**PRELIMINARY DRAINAGE REPORT  
FOR  
SCHMIDT PARCEL **EARLY GRADING** AN**

**May 2022  
Project No. 25188.13**

**CDR-22-007**

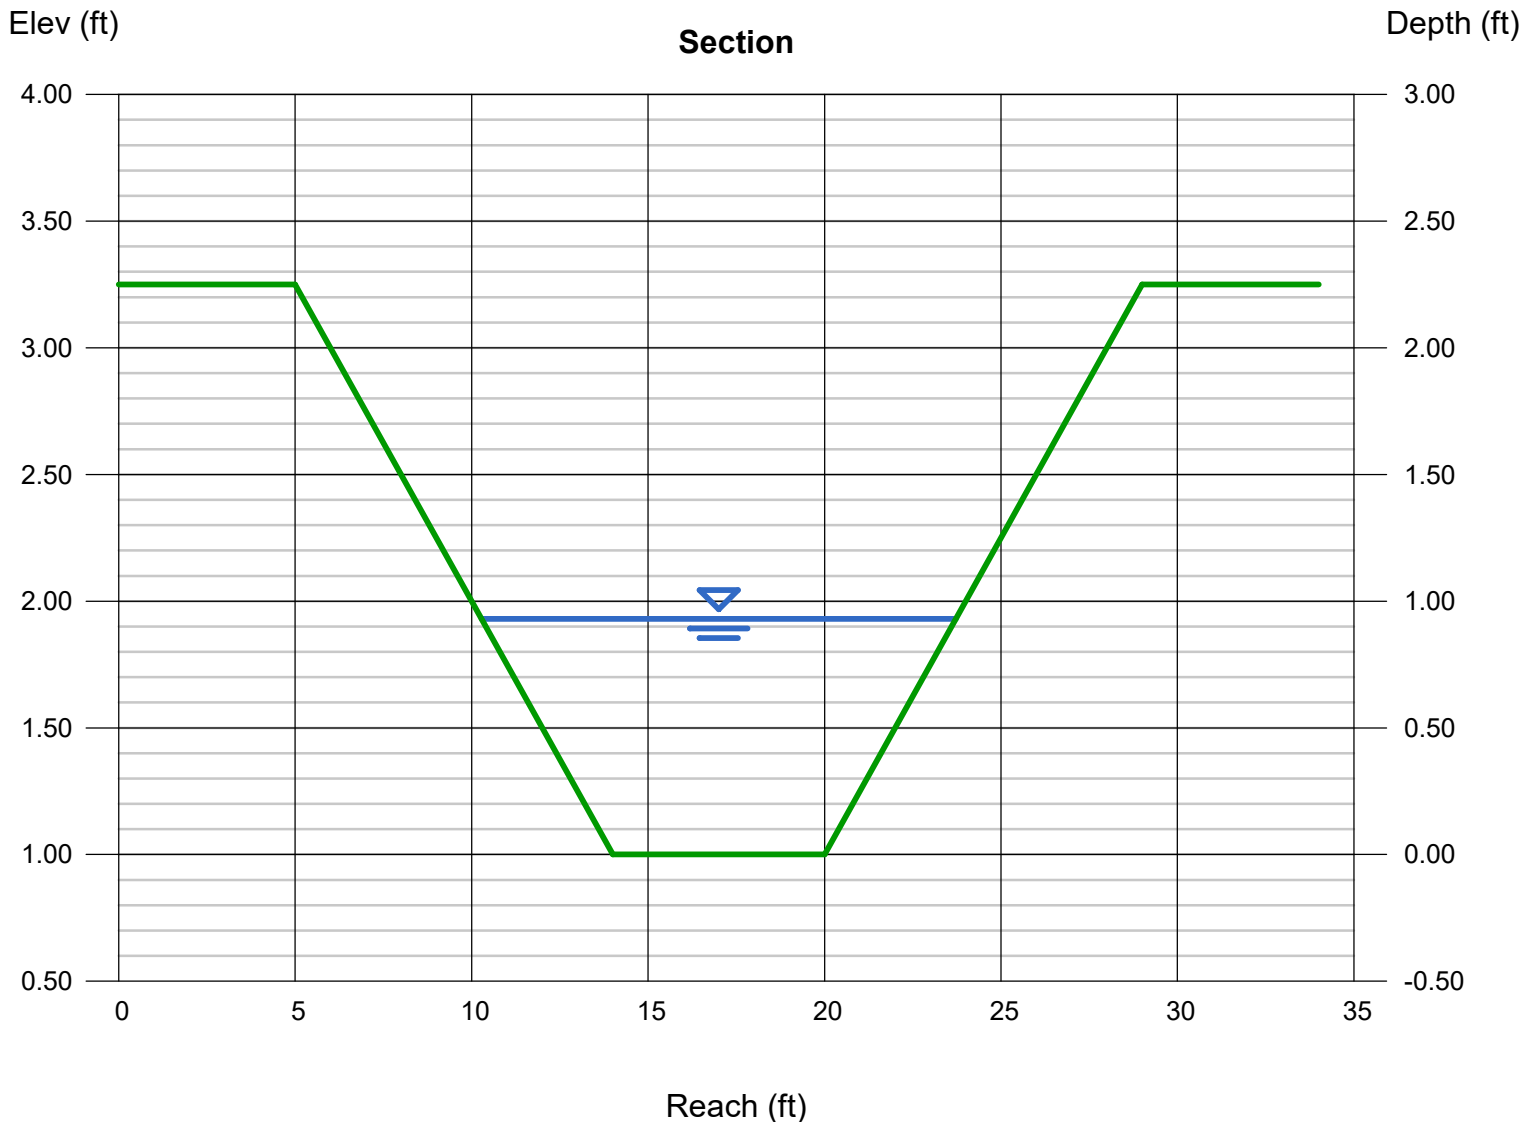
Swale C-C added

SCHMIDT PARCEL  
PROPOSED DRAINAGE MAP

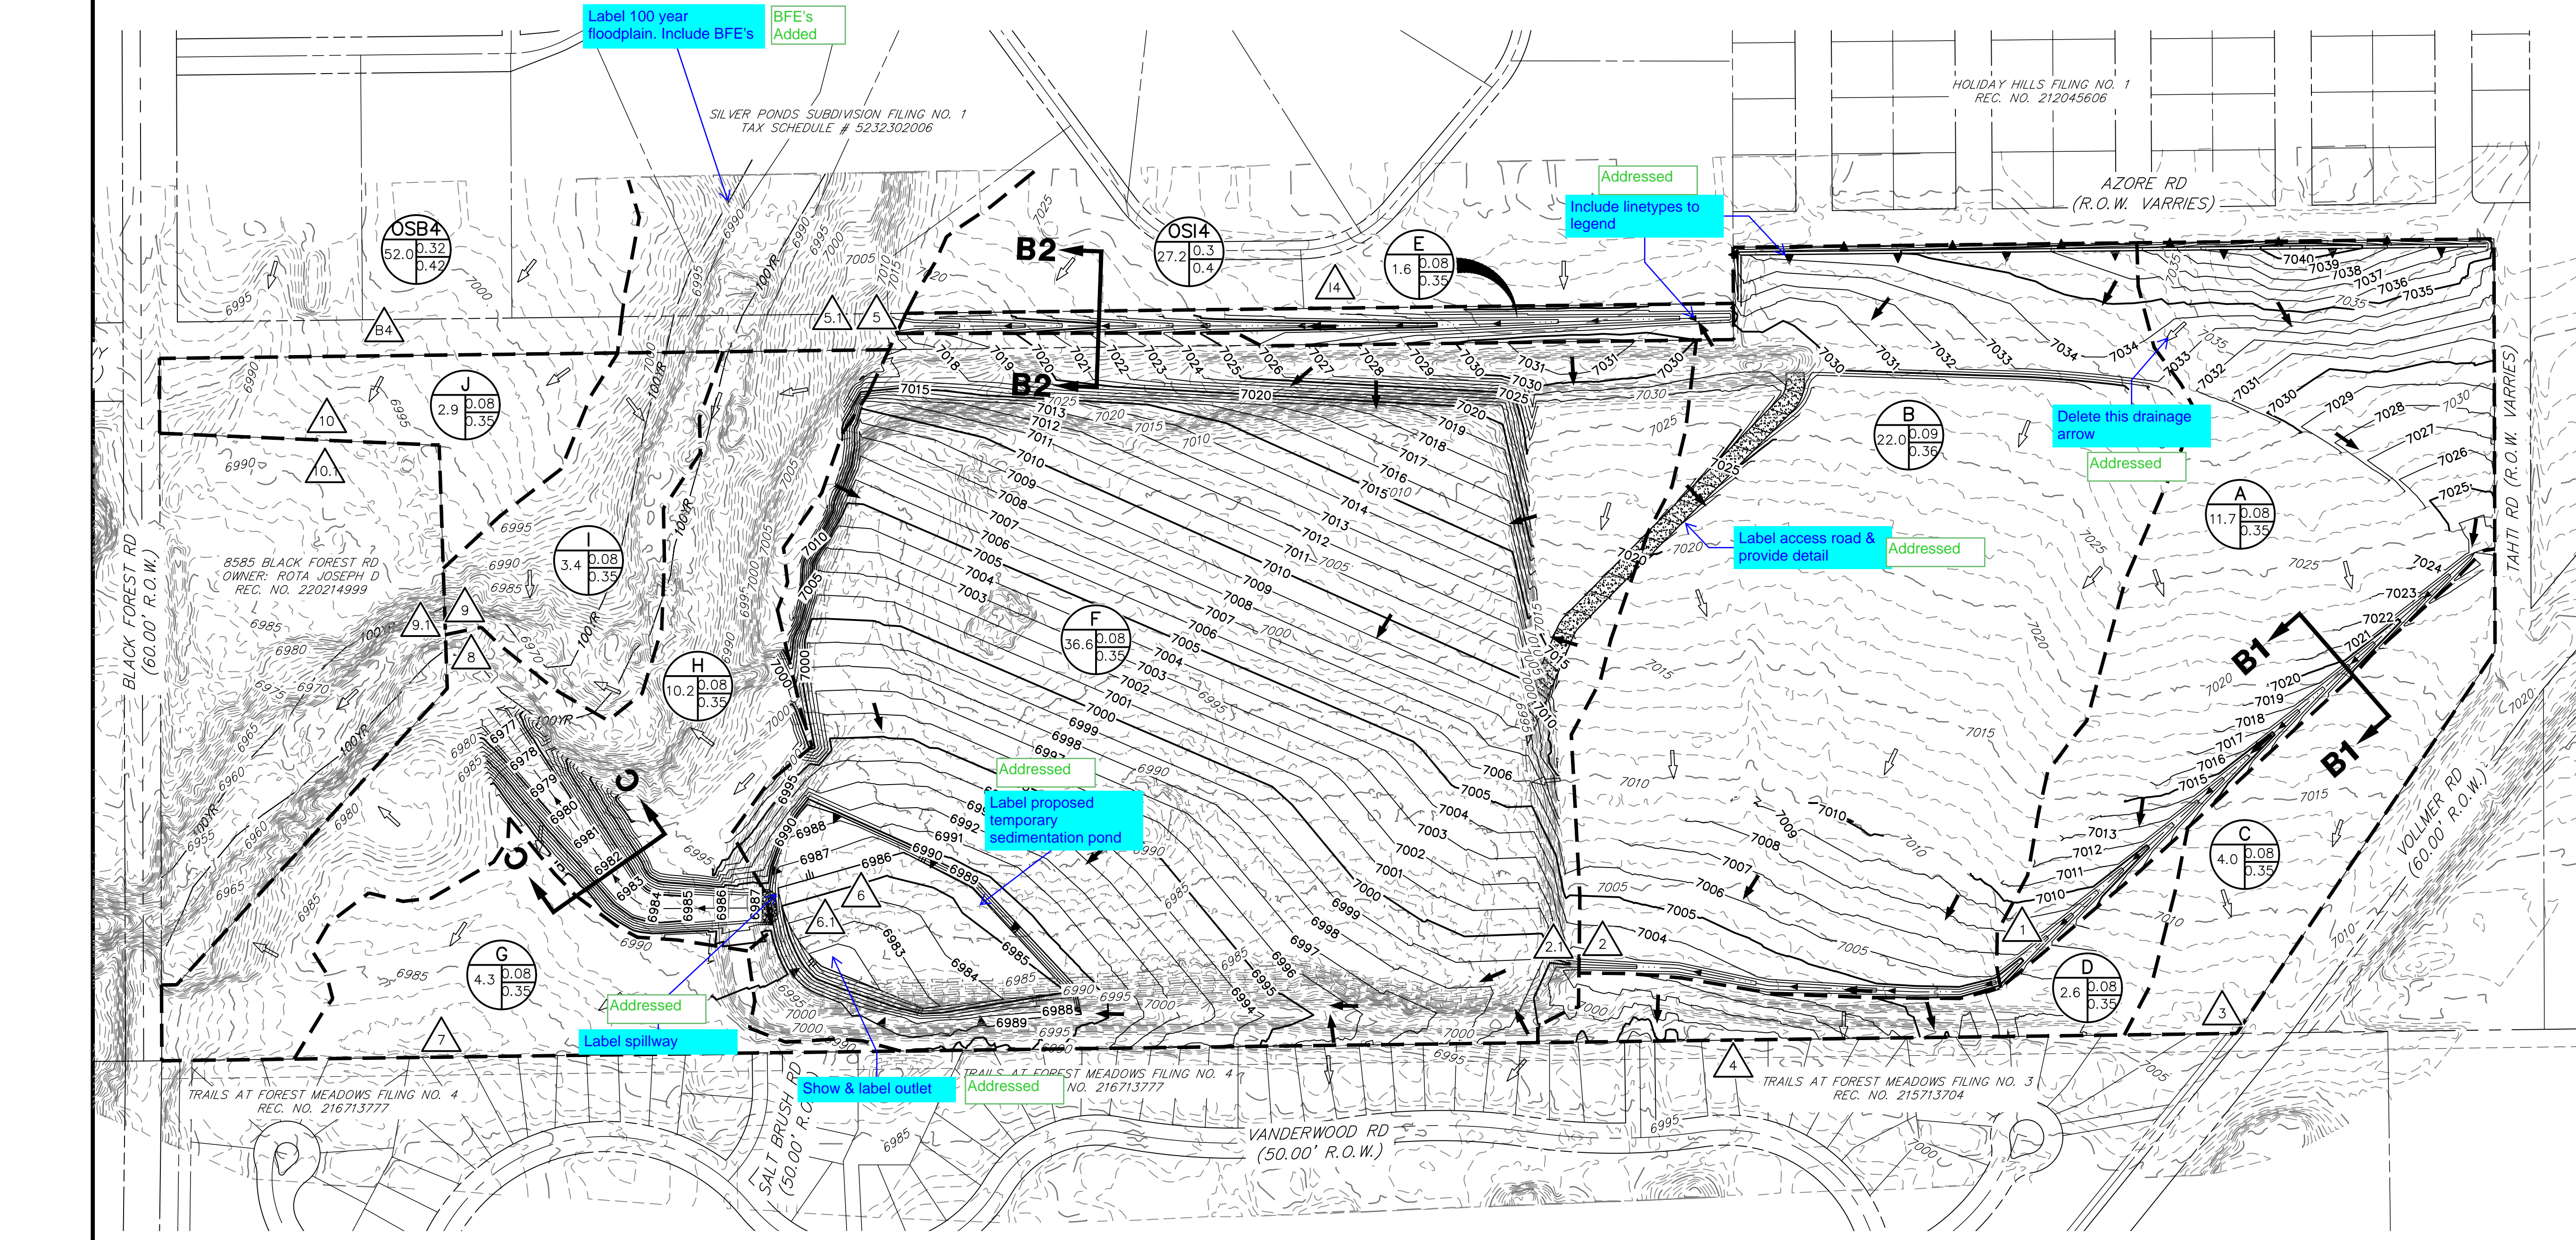
Add OS14 & OS B4 to table Addressed

Match linetype in plan

Add OS14 & OS B4 to table

Add OS14 & OS B4 to table

Delete this drainage arrow

Show & label outlet

Match linetype in plan

Label access road & provide detail

Match linetype in plan

Add OS14 & OSB4 to table

Show & label floodplain. Include BFE's

- Show boundary between Sand Creek &  
Cottonwood Creek Drainage basins

- Show & label property boundary
